GULF STATES UTILITIES COMPANY

December 9, 1983

River Bend Station Units 1 and 2
Docket Nos. 50-458/50-459

Enclosed are Gulf States Utilities Company's responses to Request for Additional Information identified by the Nuclear Regulatory Commission's Instrumentation and Control Systems Branch (ICSB) and endorsement of the Licensing Review Group-II issues 1-ICSB through 7-ICSB. Attachment 1 of this letter summarizes the Staff requests identified in a letter dated July 28, 1982. The following enclosures contain the actual written changes to the FSAR including all inserts, tables, and figures. These changes will be incorporated into the FSAR in the next amendment.

FIGURE 7.2-1

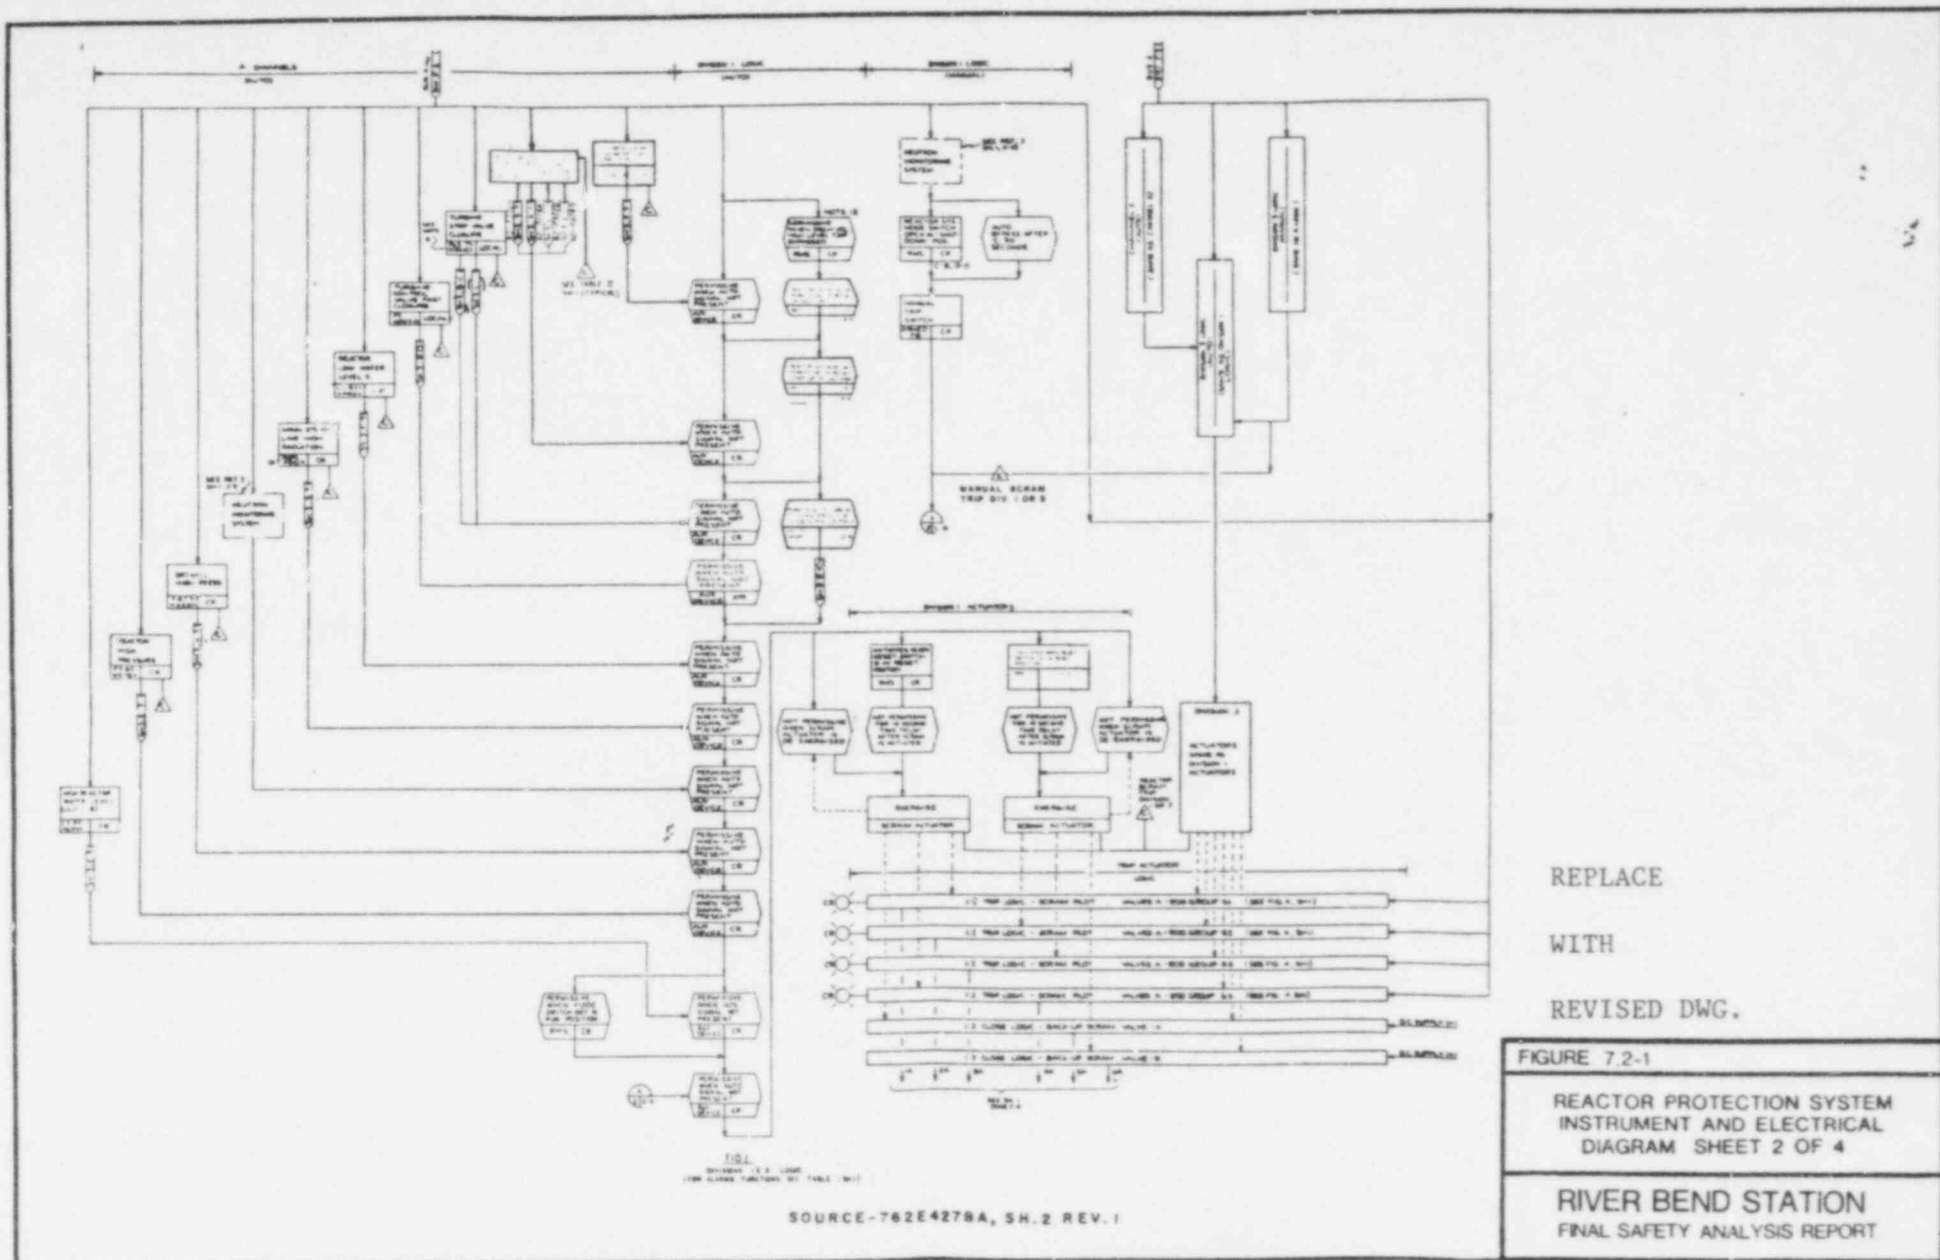
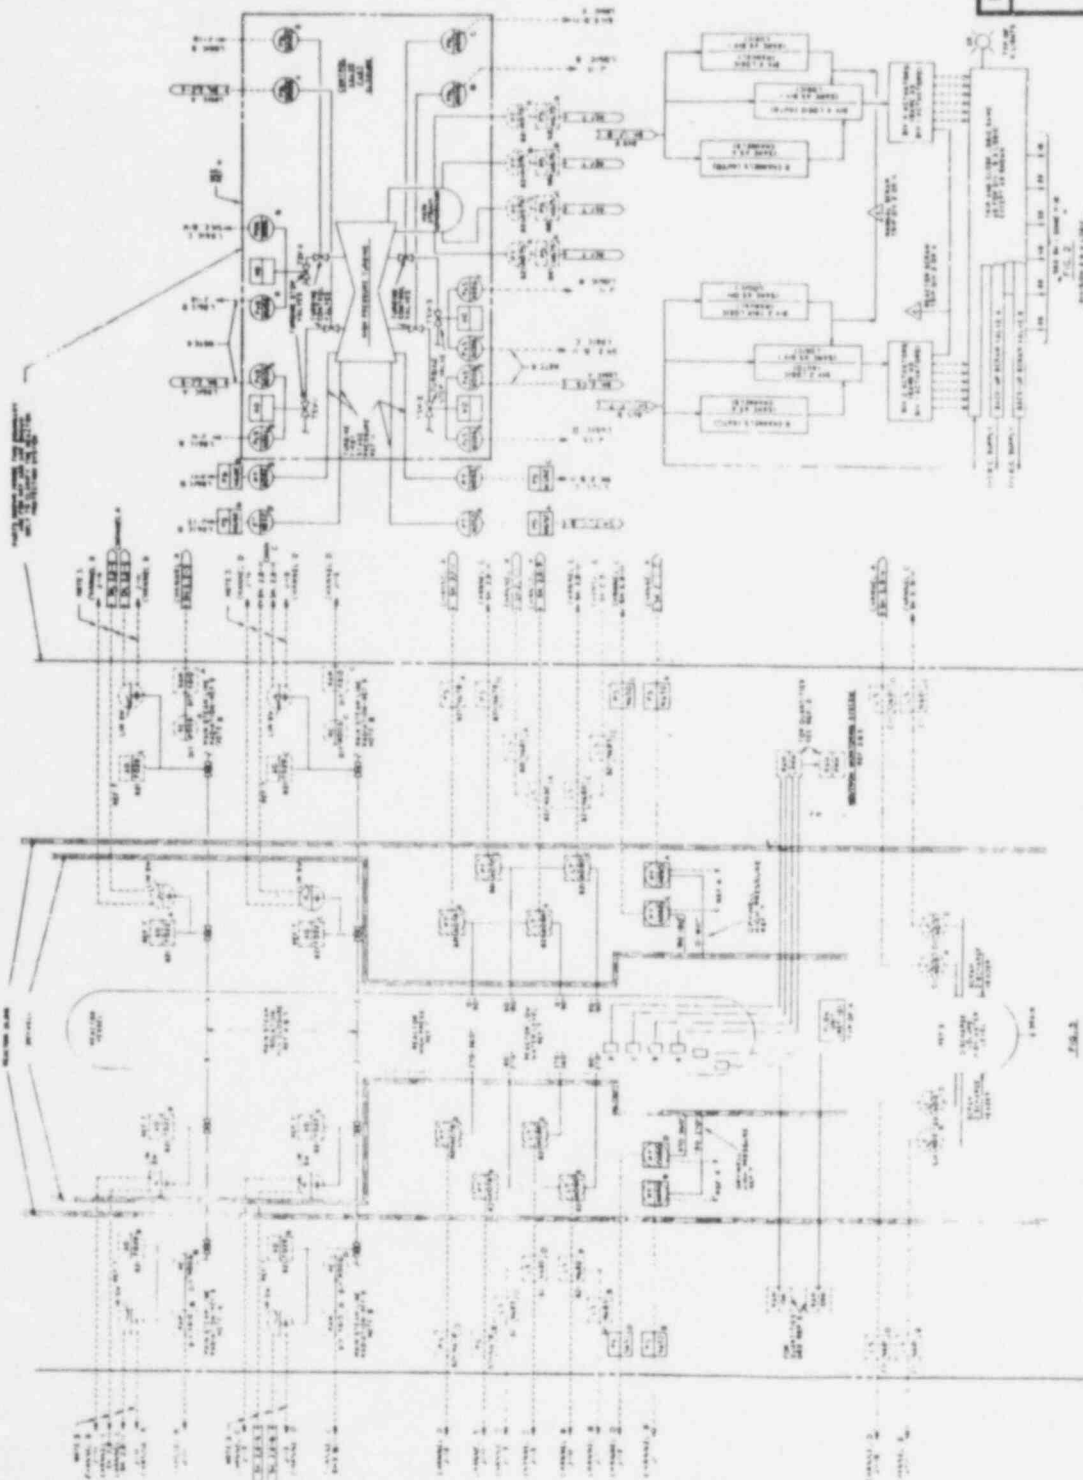
During an earlier review (Hatch Unit 2), the staff questioned the adequacy of protection afforded the Class 1E RPS against possible sustained overvoltage or undervoltage conditions from the non-Class 1E RPS power supply. Several similar plants (i.e., Perry and Grand Gulf) have provided an electrical protection assembly (EPA) between the RPS and its power sources. No reference to the EPA could be found in Chapter 7 or 8 of the River Bend FSAR. State whether the River Bend design will incorporate an EPA between the RPS and its power sources. If so, the FSAR should be modified accordingly. If not, describe how the RPS is protected from degraded voltage and frequency conditions.

The response to this request is provided in revised Sections 7.2.2.2 and 8.3.1.1.3.8.1. A revised Figure 7.2-1 showing the EPA ~~will be provided by September 1983.~~
is

REPLACE
WITH
REVISED DWG.

REACTOR PROTECTION SYSTEM
INSTRUMENT AND ELECTRICAL
DIAGRAM SHEET 3 OF 4

FIGURE 7.2-1

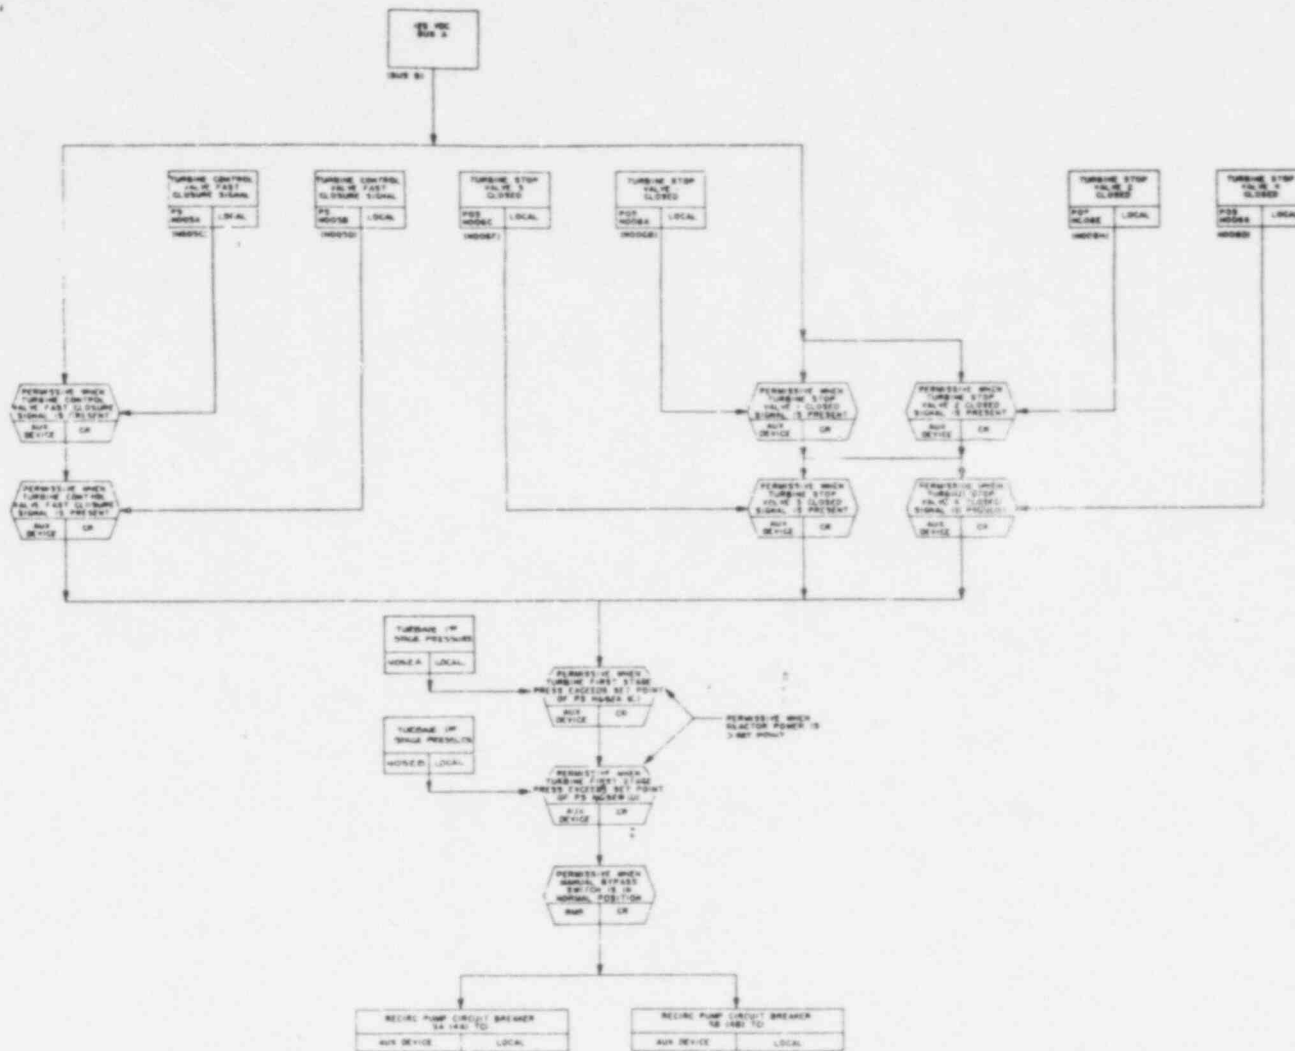
The discussion on Scram Discharge Instrument Volume (SDIV) Water Level, FSAR Section 7.2.1.1, states that four pressure (level) transmitters sense SDIV level and provide inputs to the RPS. However, Section 4.6.1.1.2.4.2.5 states that both float sensing and pressure (level) sensing devices are used for the automatic scram function. Resolve this apparent discrepancy.

REPLACE
WITH
REVISED DWG.

REACTOR PROTECTION SYSTEM
INSTRUMENT AND ELECTRICAL
DIAGRAM SHEET 4 OF 4

The response to this request is provided in revised Sections 7.2.1.1, Item 2.h, and 4.6.1.1.2.4.2.5. A revised Figure 7.2-1 ~~will be provided by September 1983.~~
is

Note: Revised Fig. 7.2-1 is provided
with the response to Question
421.016.

FIGURE 7.3-1

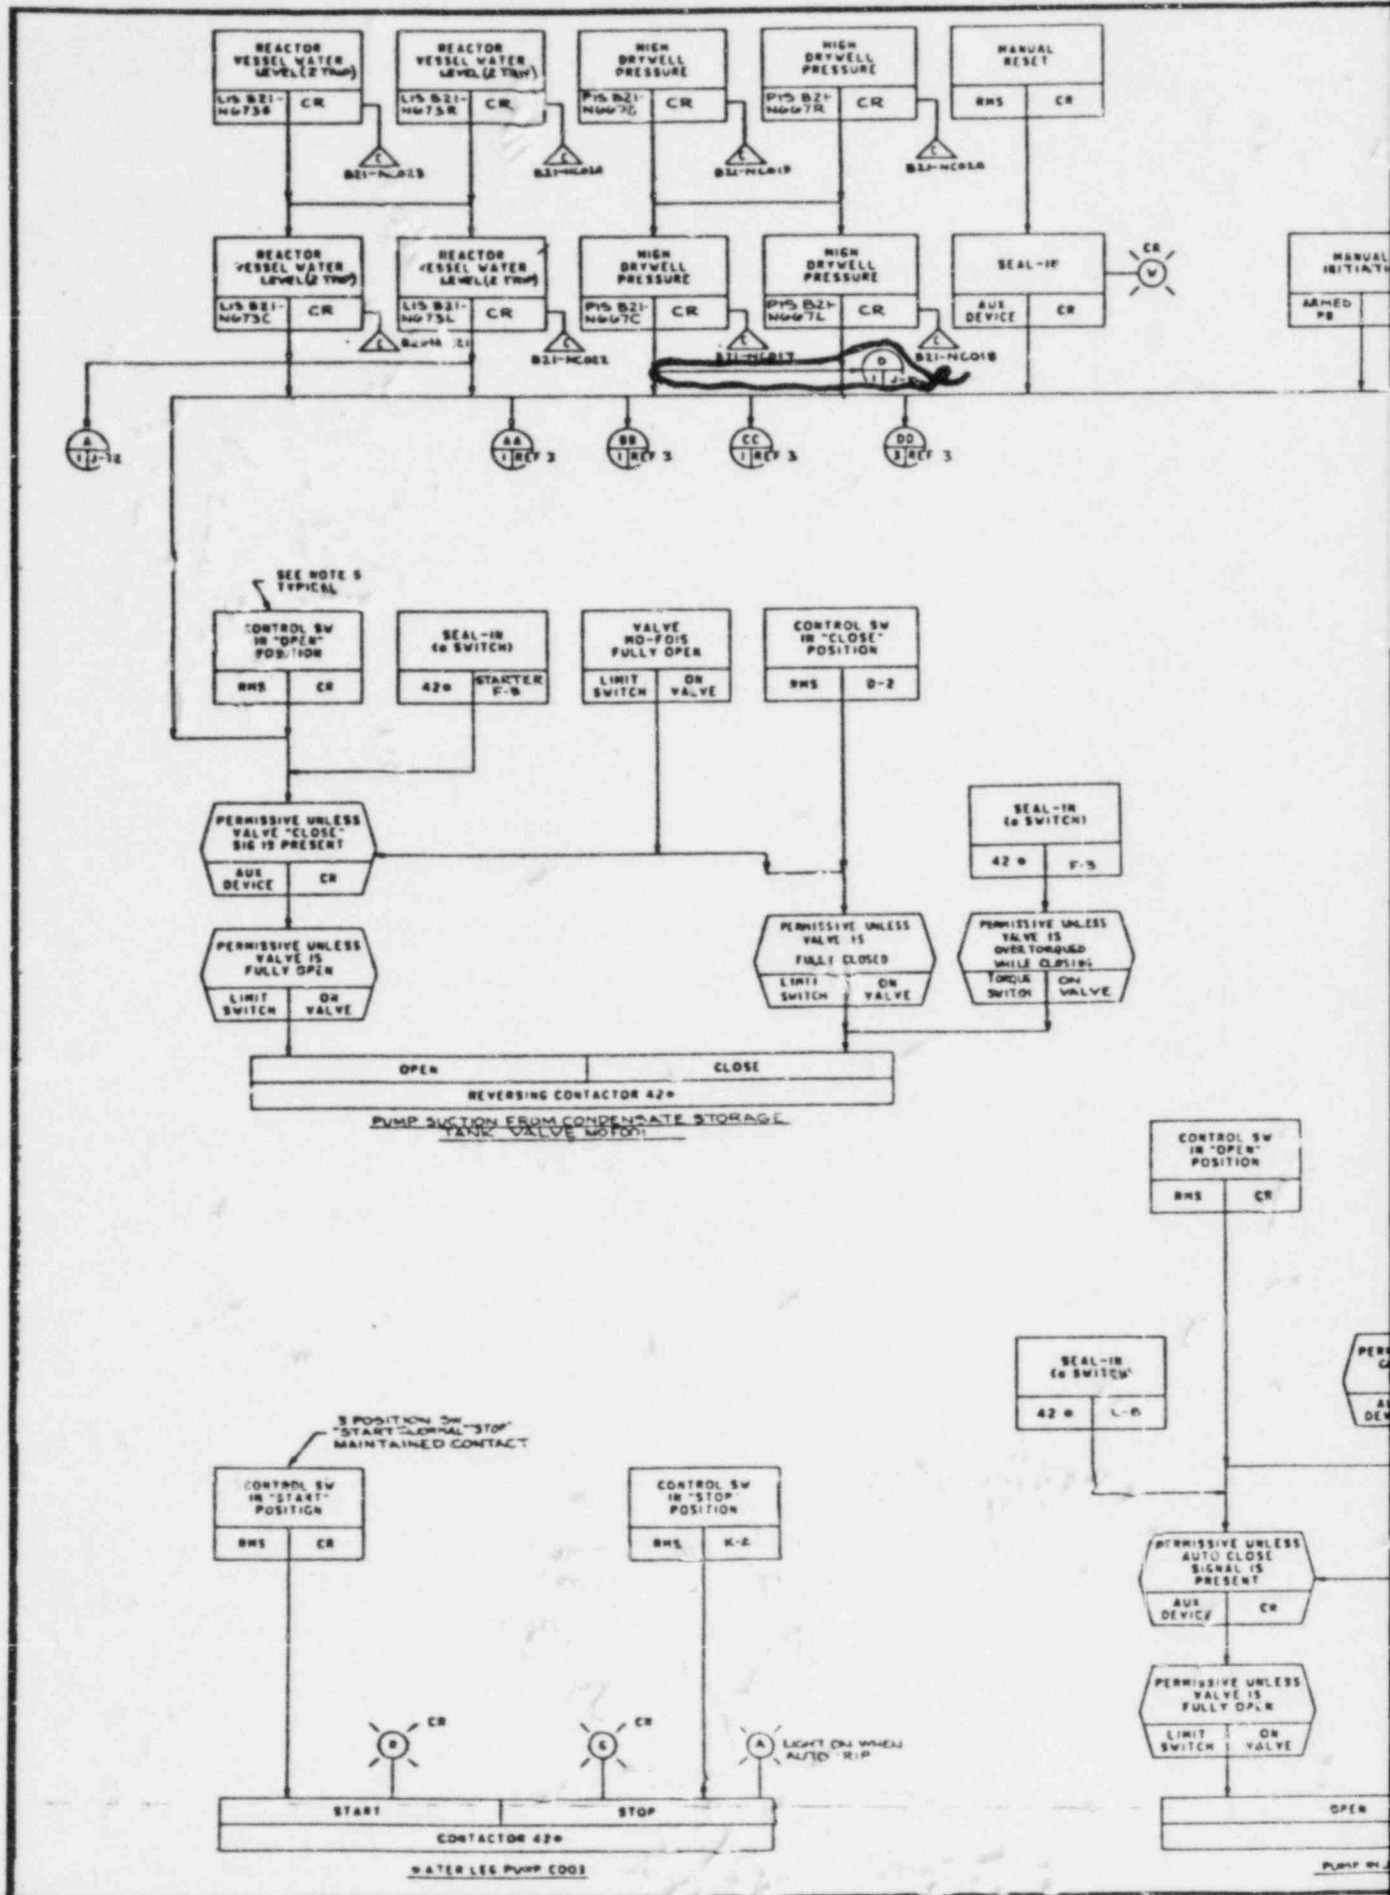
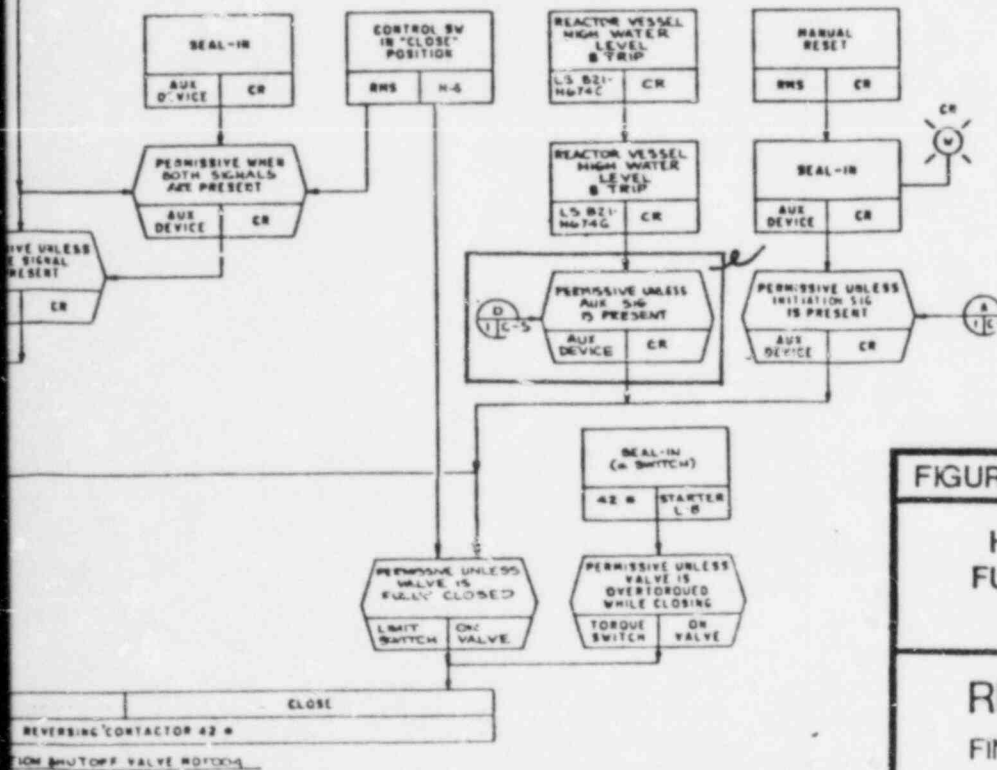
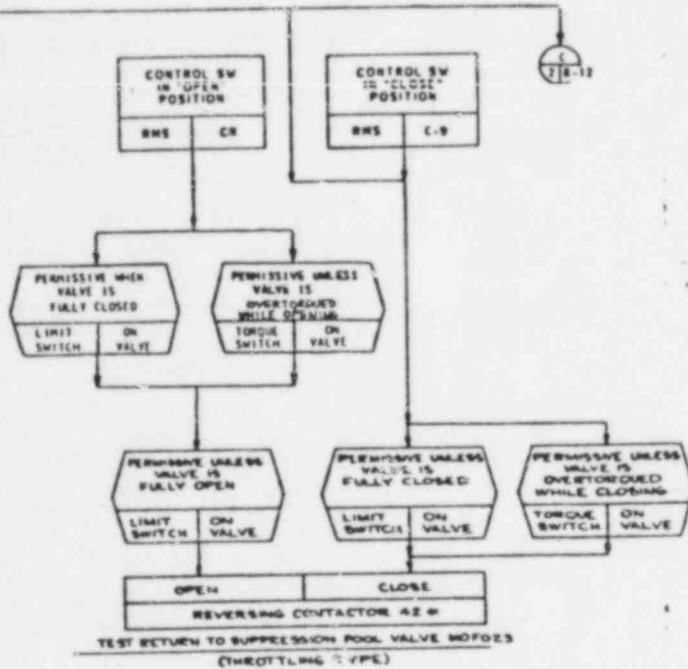
In the discussion of the High Pressure Core Spray (HPCS) System, Section 7.3.1.1.1.1, the statement is made that the HPCS provides makeup water to the reactor until the vessel water level reaches the high level trip (trip level 8) and there is no high drywell pressure signal present. The high drywell pressure interlock has been removed in other BWR HPCS designs since the potential exists for flooding of the steam lines and subsequent damage to safety-related valves and primary system piping. State whether the River Bend design will be modified to eliminate this interlock. If so, revise the FSAR and associated drawings accordingly.

An electrical interlock is incorporated into the HPCS circuitry that prevents the injection valve from closing automatically upon receipt of the high reactor water level (L8) signals if a high drywell pressure signal still exists. The interlock was added as a result of the NRC staff review of GESSAR-238, which indicated that the interlock was needed to assure diversity of HPCS initiation signals and to prevent premature HPCS termination. However, flooding of the steam lines could result in damage to the safety/relief valves and primary system piping unnecessarily, since the interlock tends to keep the HPCS in operation past the point of reflooding the core and does not significantly add to the overall safety. We require justification for use of the present logic or removal.

GSU endorses the LRG-II issue 13-RSB which states the electrical interlock will be removed. This modification allows the HPCS flow to be shutoff at high reactor vessel water level (level 8) when a high drywell pressure signal is present and prevents the flooding of the steam lines if the vessel is overfilled. ~~An FSAR amendment will be provided to reflect this modification when the design change is complete.~~

This is reflected in revised Sections 6.3.2.2.1 and 7.3.1.1.1.1 and in revised Figure 7.3-1.
